**ADDENDUM
NO. 3**

**BOONE GROVE HIGH SCHOOL
RENOVATION AND RELATED WORK
Valparaiso, IN 46341**

ADDENDUM THREE

Addendum Three (AD.03) to the drawings and specifications prepared by Gibraltar Design for **Boone Grove HS Renovation and Related Work** for Porter Township School Corporation, Valparaiso, Indiana.

UNIT "C" ARCHITECTURAL FIRST FLOOR DEMOLITION PLAN

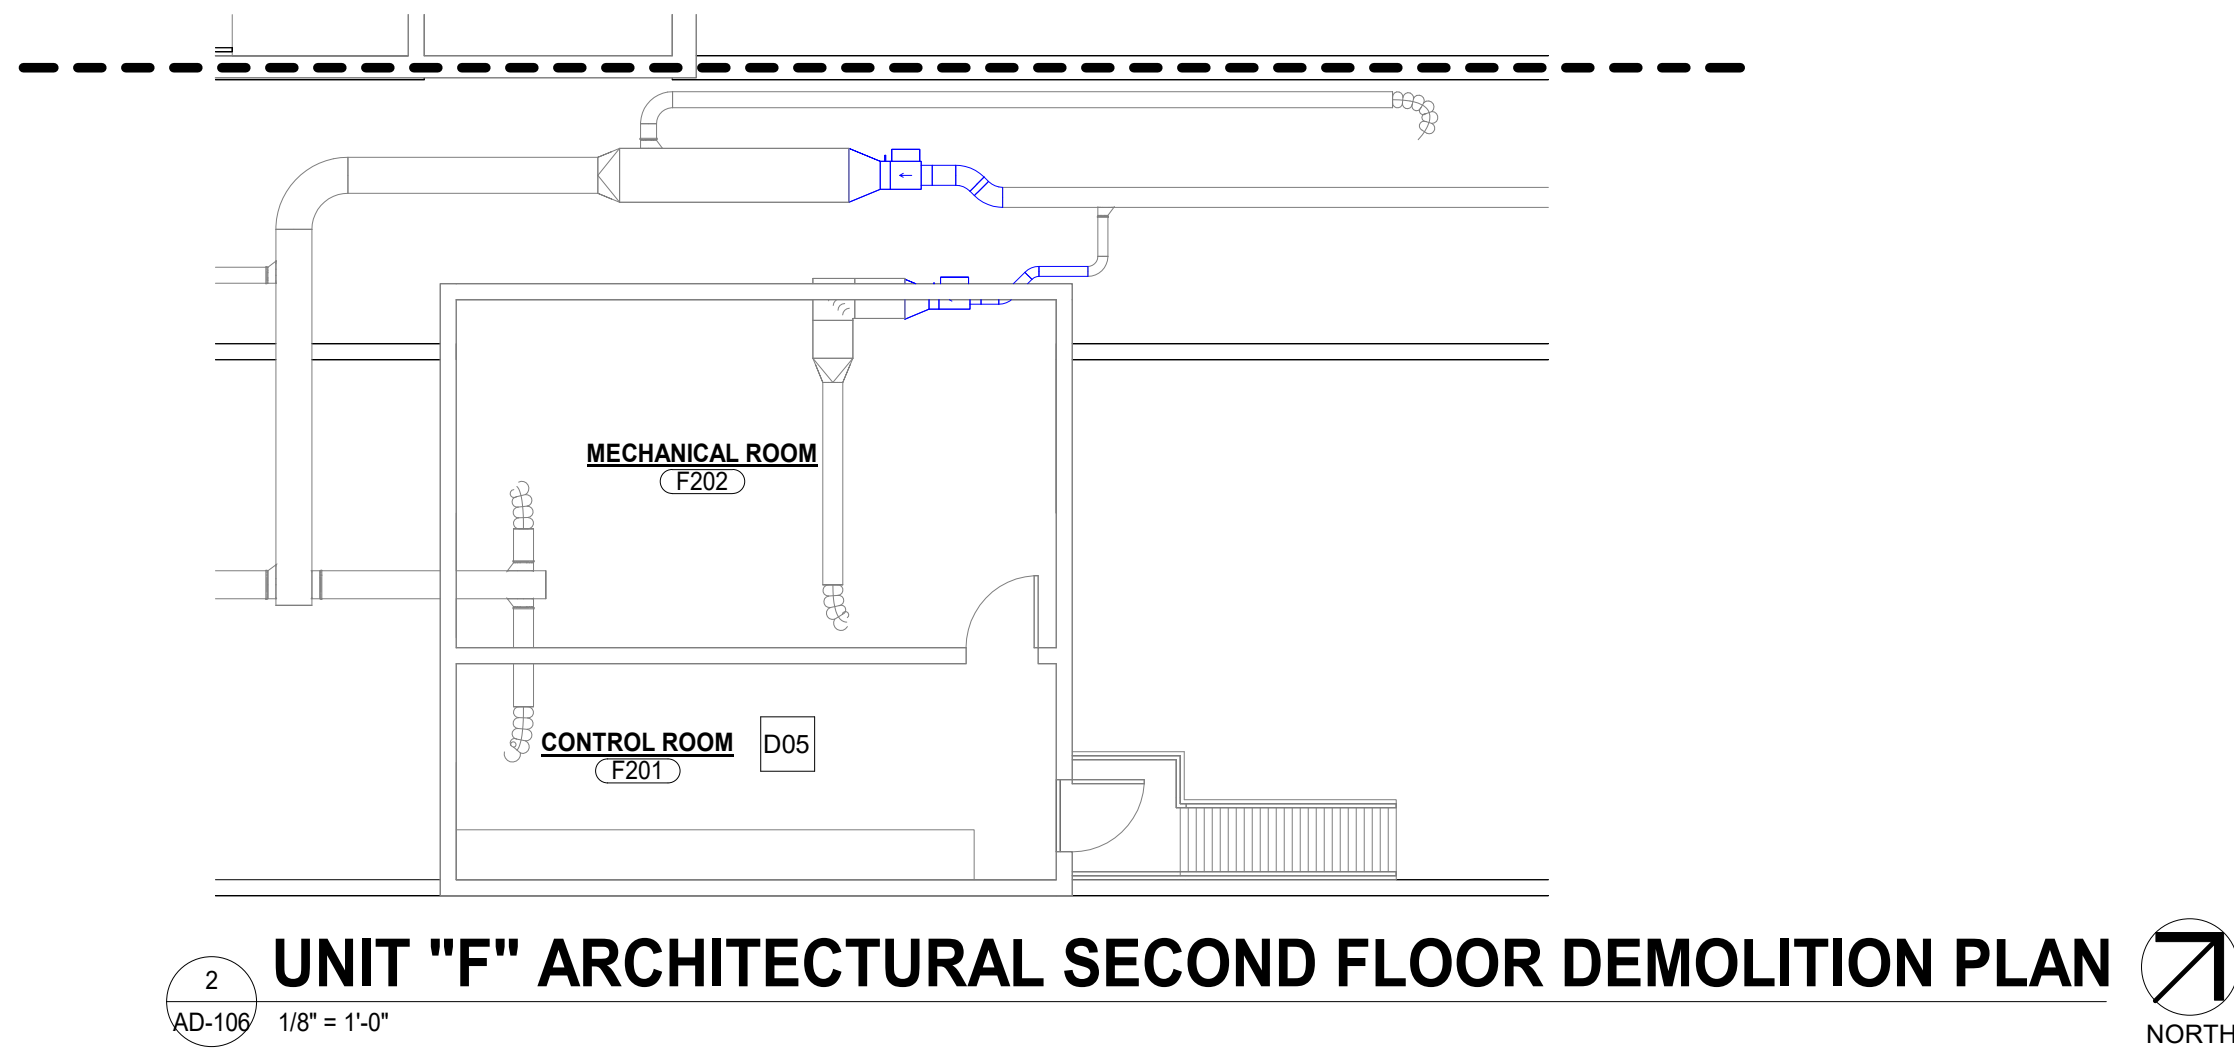
- A. Refer to revised, full-size drawing, included in this Addendum, for revisions.
1. Keynotes D27 and D28 added to sheet.
 2. Keynotes D27 added to room C124.

UNIT "F" ARCHITECTURAL FIRST FLOOR PLAN

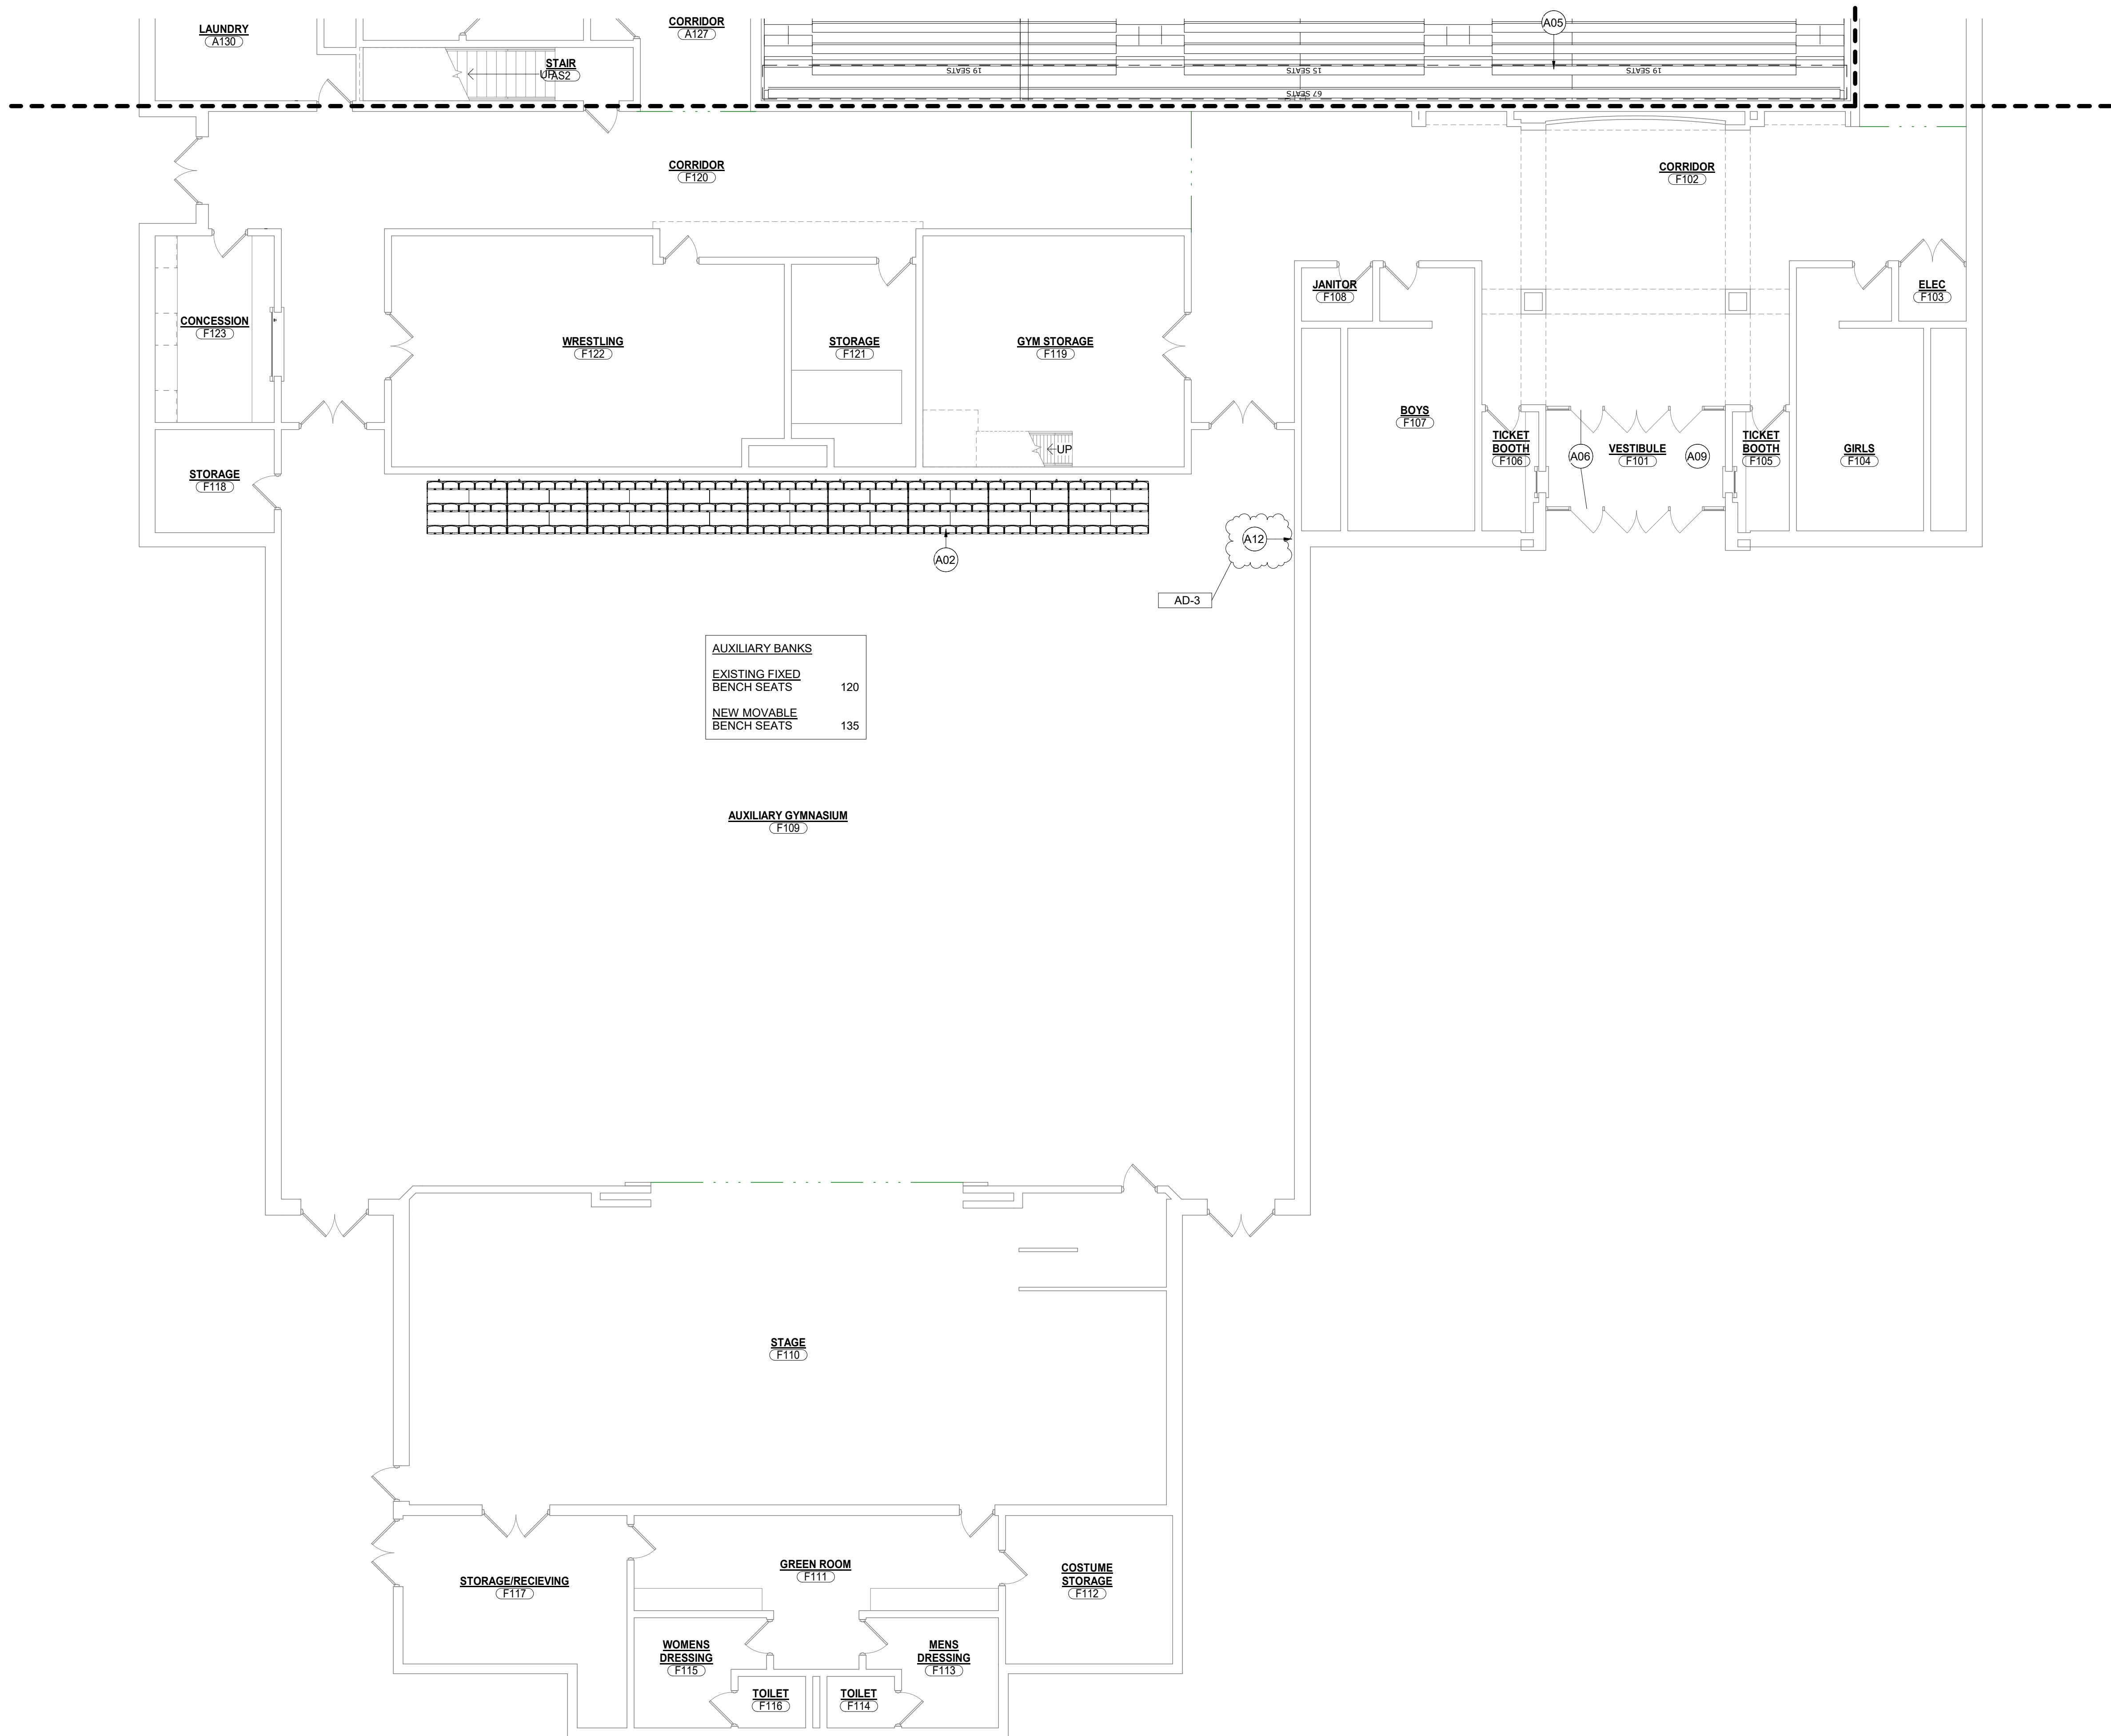
- A. Refer to revised, full-size drawing, included in this Addendum, for revisions.
 - 1. Keynotes A11 and A12 added to sheet.
 - 2. Keynote A12 added to room F109.

UNIT "B" ARCHITECTURAL FIRST FLOOR CEILING PLAN

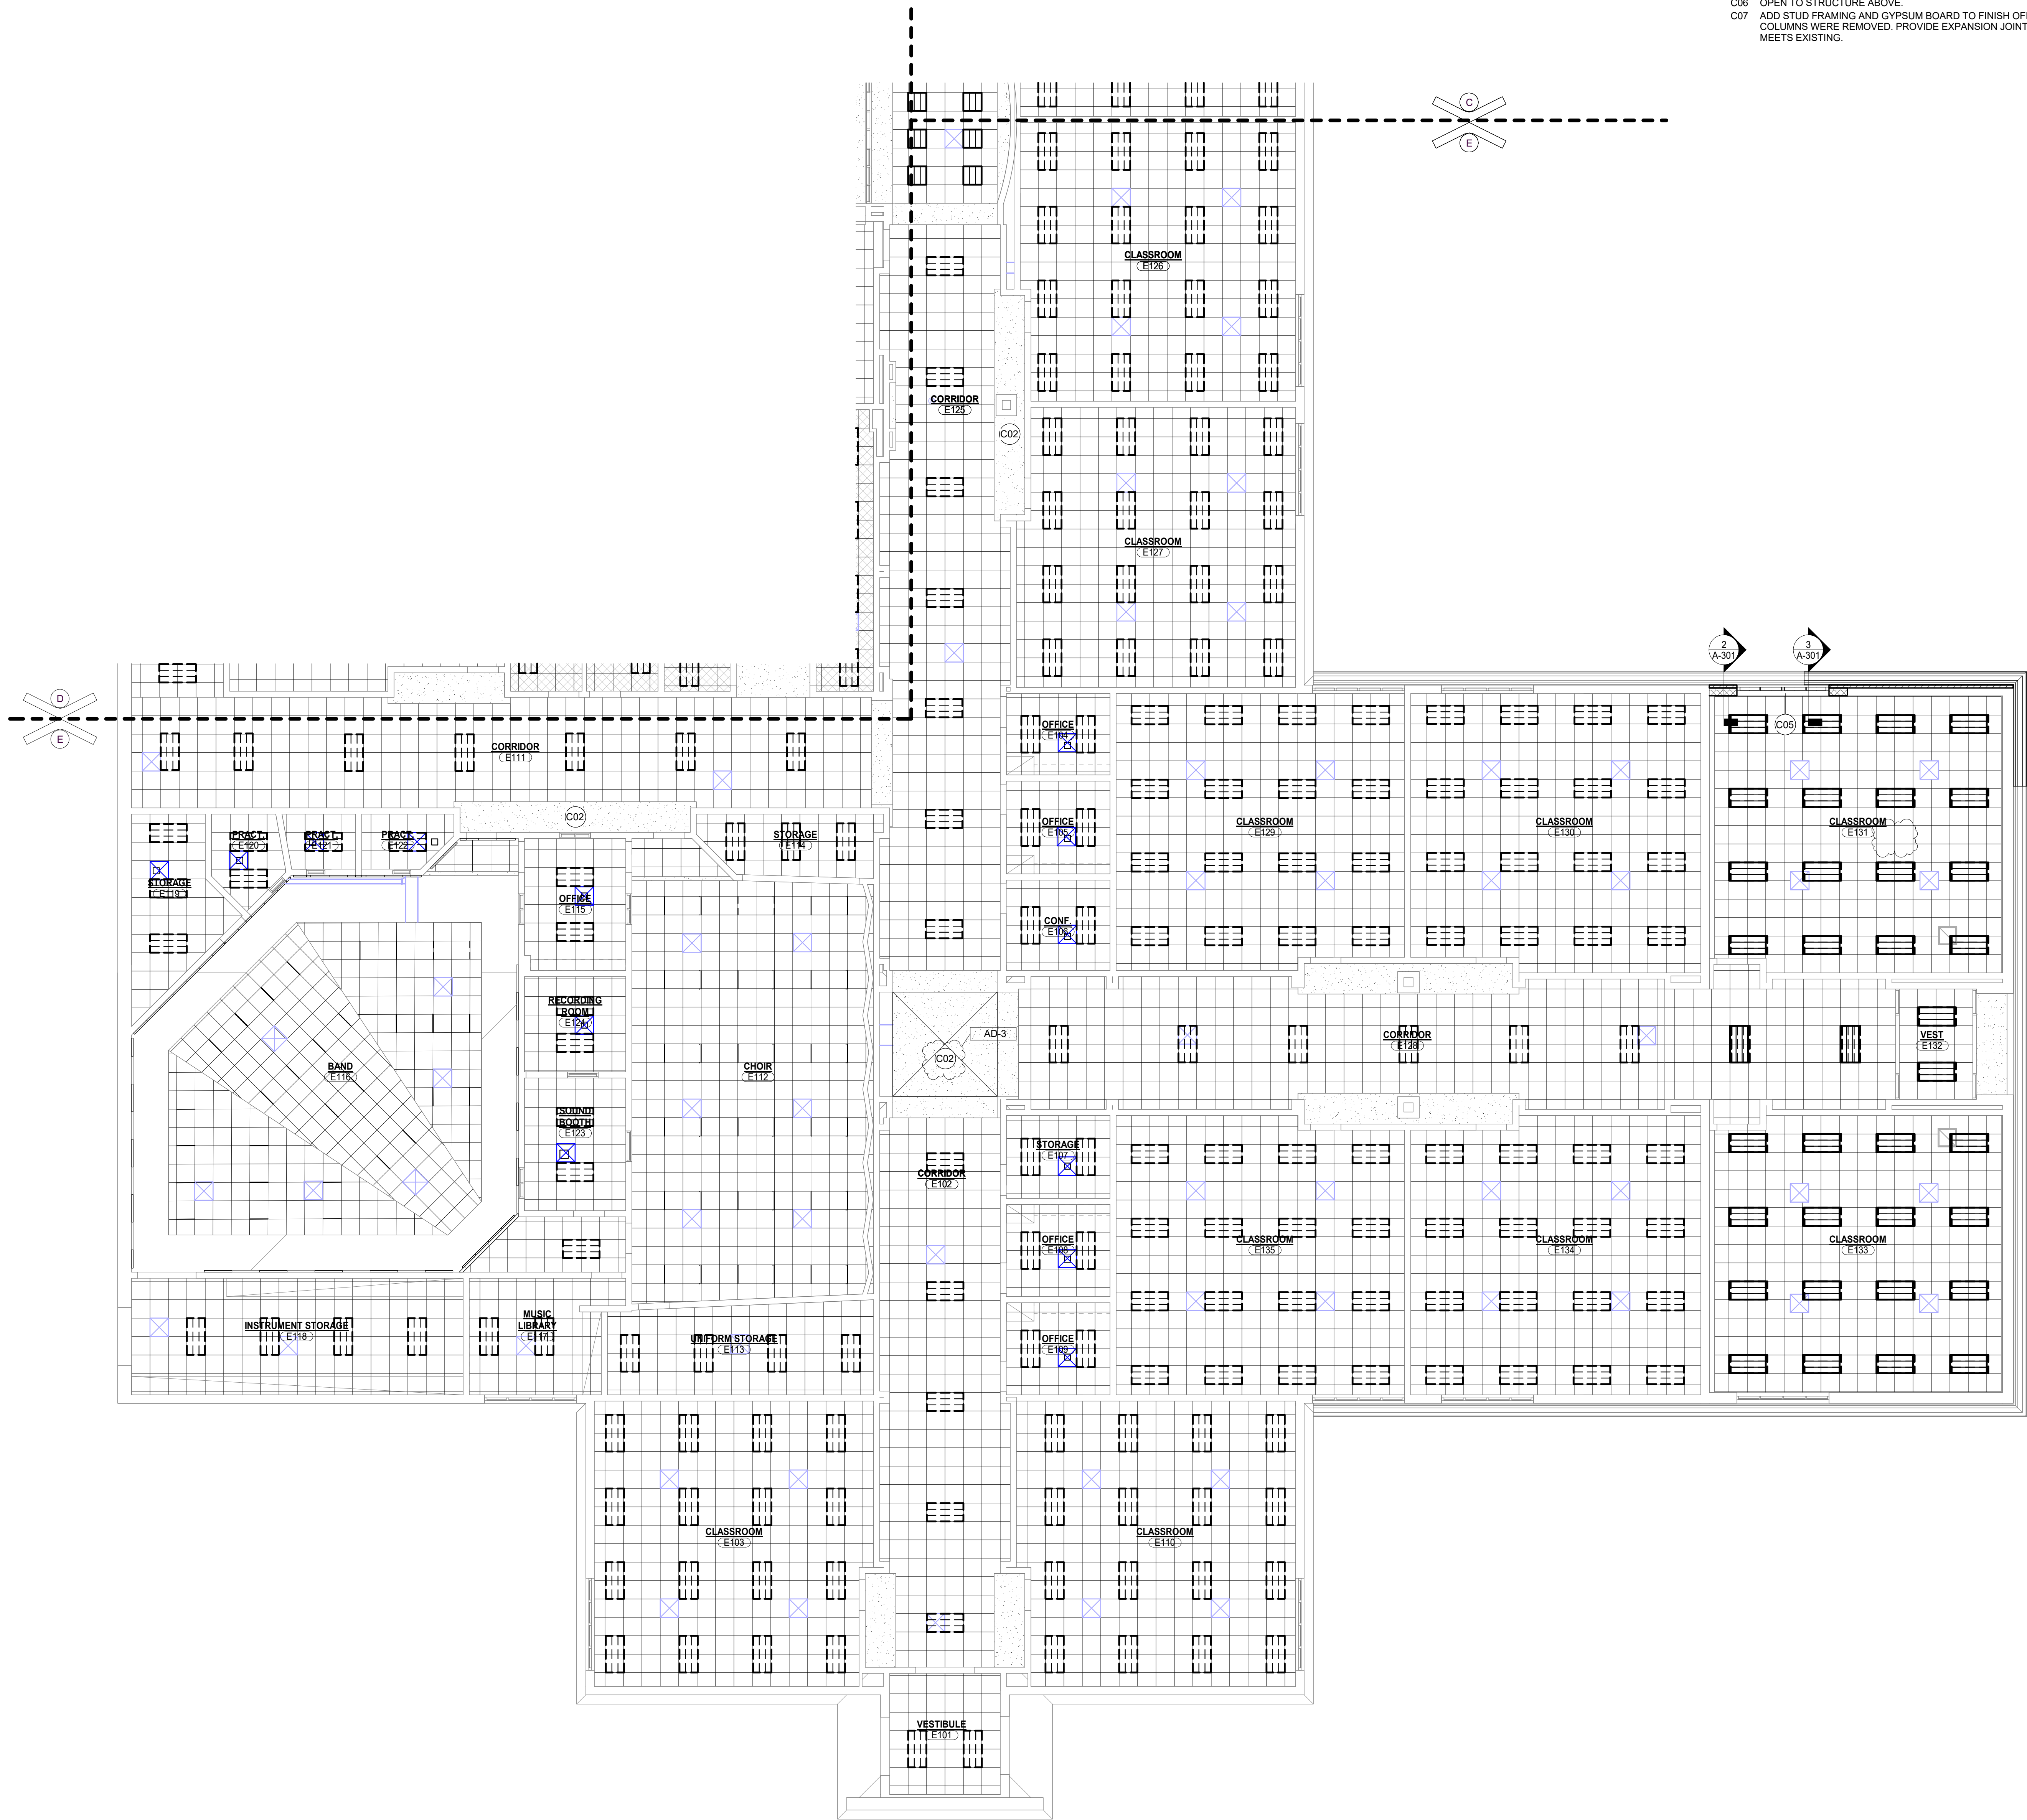
- A. Refer to revised, full-size drawing, included in this Addendum, for revisions.
 - 1. Revised the Cafeteria B-105 ceiling type to ACT-5.
 - 2. Revision to REFLECTED CEILING PLAN KEYNOTES number C04 to read 'NOT USED'.
 - 3. Removed references of note C04 from the ceiling plans.
 - 4. Added note "K" to GENERAL NOTES that reads "REFER TO SPRINKLER SHEETS FOR EXTENT OF SPRINKLER WORK, INCLUDING SELECTED AREAS OF BRANCHLINE RELOCATION."
